Coastal Use Permit (5.1.24) Foggy Water Marina (Markups & Summary).pdf Markup Summary

FOGGY WATERS MARINA
PROPOSED FOGGY WATERS MARINA RENOVATIONS ST. TAMMANY PARISH, LOUISIANA, VICINITY MAP

PROPOSED FOGGY WATERS MARINA RENOVATIONS
ST. TAMMANY PARISH, LOUISIANA, OVERVIEW MAP

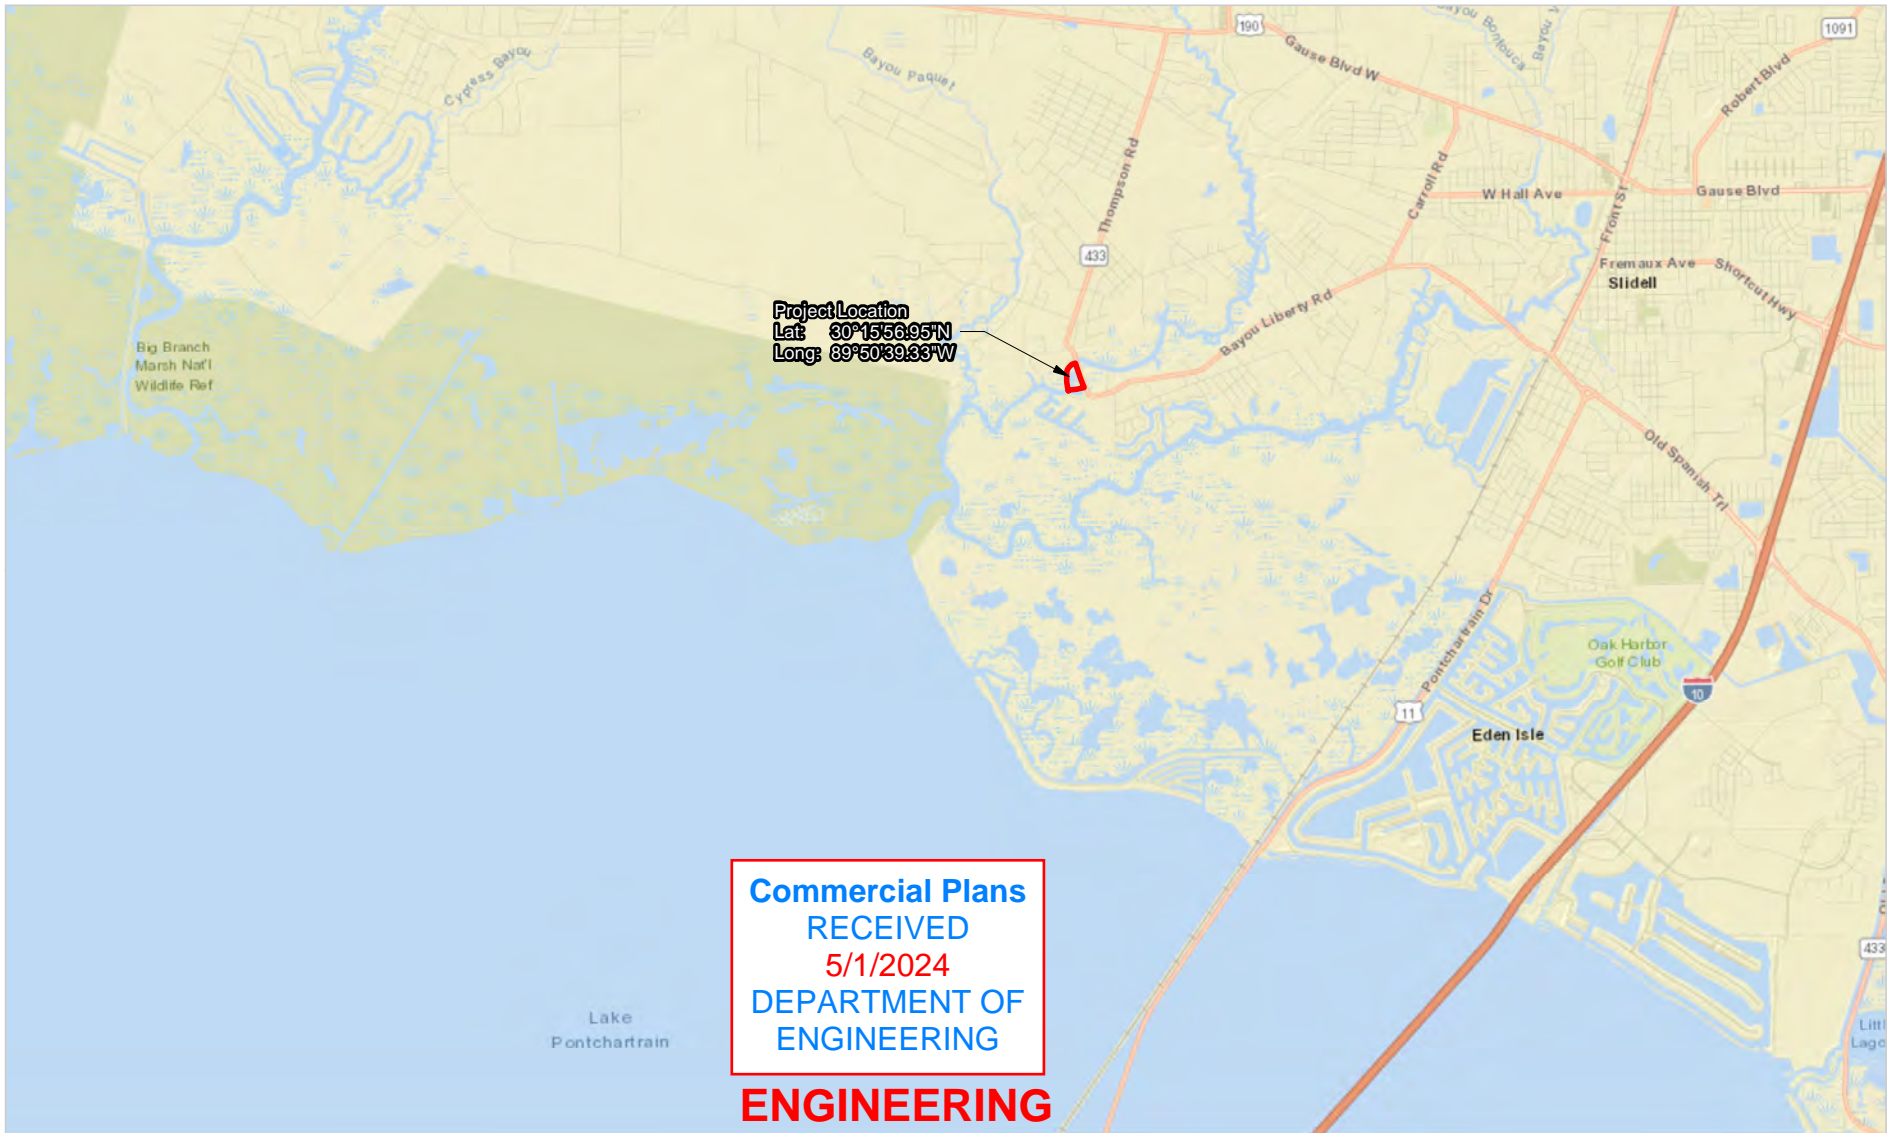
Sheets 2 through 6 are required to be stamped, signed, & dated by a licensed professional engineer to meet the fill plan requirements per STP Ordinance Sec. 115-3.

Provide temporary erosion control plan and STP Stormwater Agreement filled out and signed by the owner or contractor. (Required per STP Ordinance Sec. 115-106.)

Stamped all dwgs

See erosion control plan

A SURVEY OF 10.967 +/- ACRES a.k.a. BAYOU LIBERTY MARINA LOCATED IN SECTION 43, T-9-S, R-13-E, GREENSBURG LAND DISTRICT, ST. TAMMANY PARISH, LOUISIANA

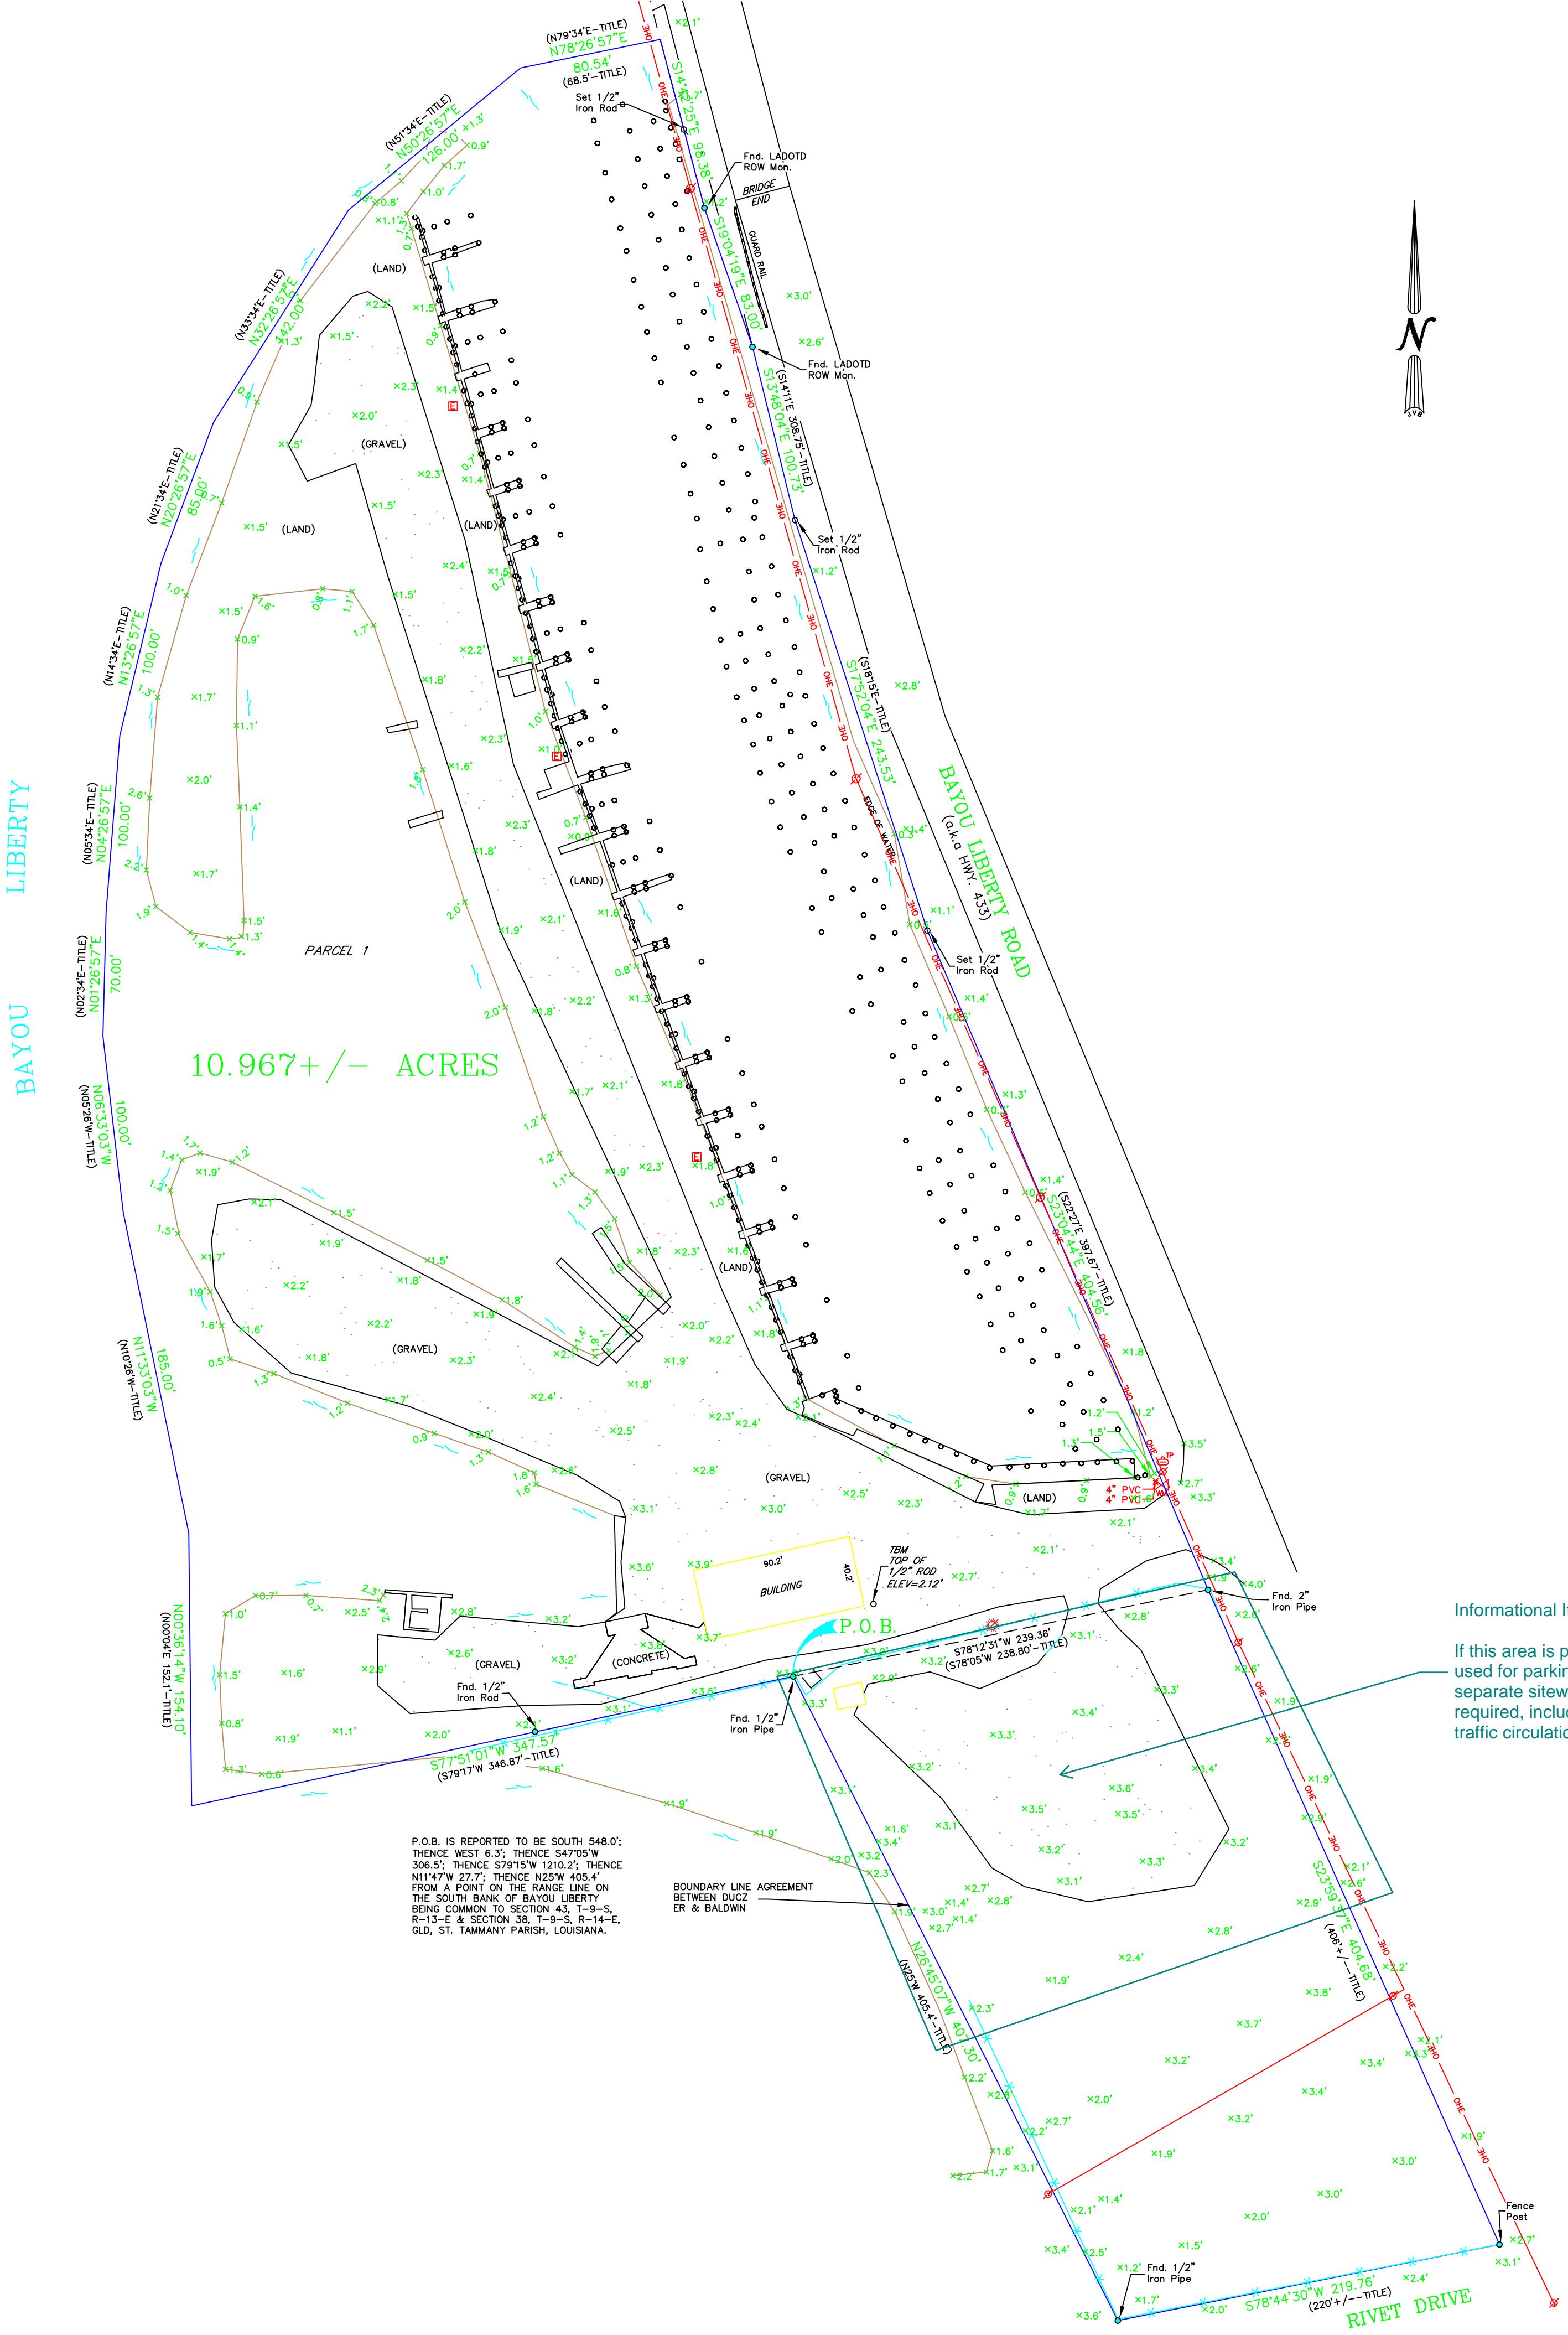
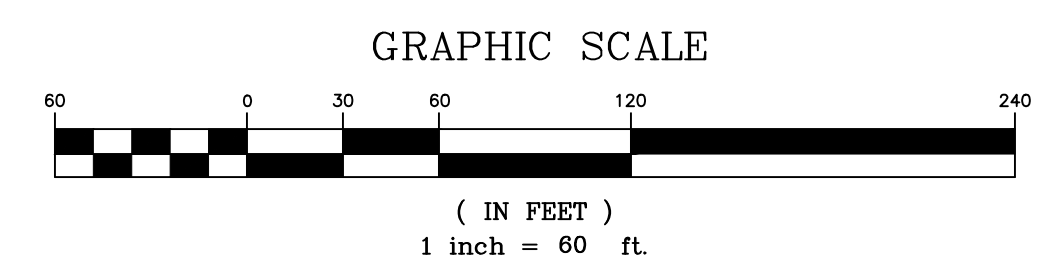
Informational Item:
If this area is proposed to be used for parking or storage, a separate sitework permit will be required, including proposed traffic circulation on site.

This is future and will be permitted separately
